Special Council Meeting

Tuesday, 10 March 2015
5:00 pm

1.	MEETING DECLARED OPEN	4
2.	APOLOGIES AND LEAVE OF ABSENCE	4
3.	ELECTRONIC MEETING ATTENDANCE	4
4.	DECLARATION OF INTEREST OF MEMBERS AND STAFF	4
5.	SUBJECT ITEMS	
5.1	Access to Lot 33 (286) Casuarina Drive, Rapid Creek, Town of Nightcliff.....	5
6.	CLOSURE OF MEETING

AGENDA ITEM: 5.1

Figure 17 – Swept Path Assessment of the B99 Design Vehicle Accessing & Egressing the Development Site and Willow Way

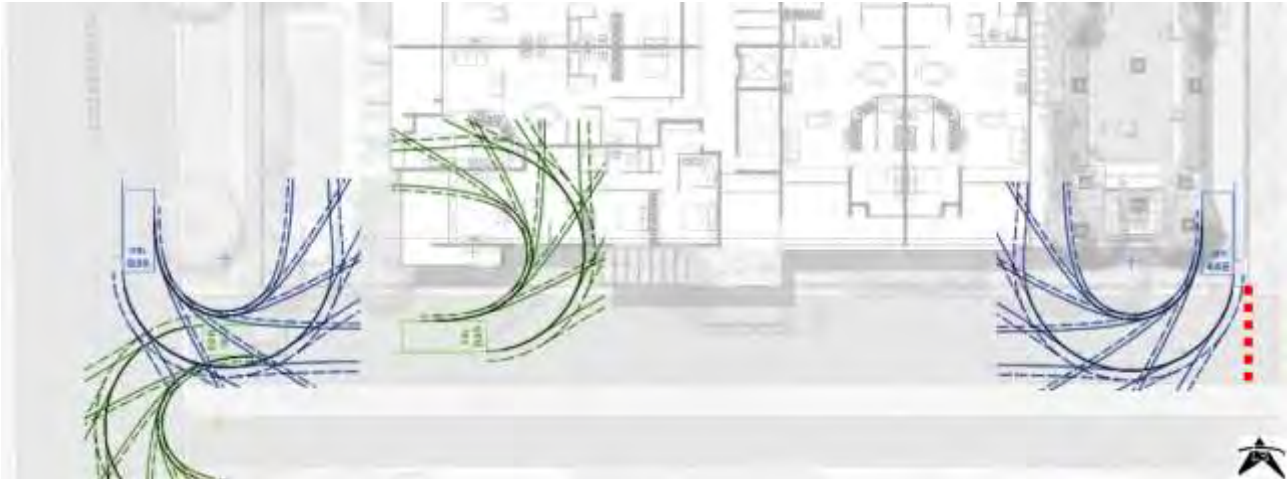
TIA Figure 17 (partial) Showing Vehicle Movements In/Out of Willow Way

Each driveway is shown as 6m wide with no taper or radius. Turn paths for a B99 vehicle provided in the TIA report show that vehicles entering either driveway would use the entire driveway width.

- Relocate kerb along Willow Way to 0.5m from fence (i.e. remove the existing footpath)
 - Increase driveway width to match the new width of Willow Way (7m)
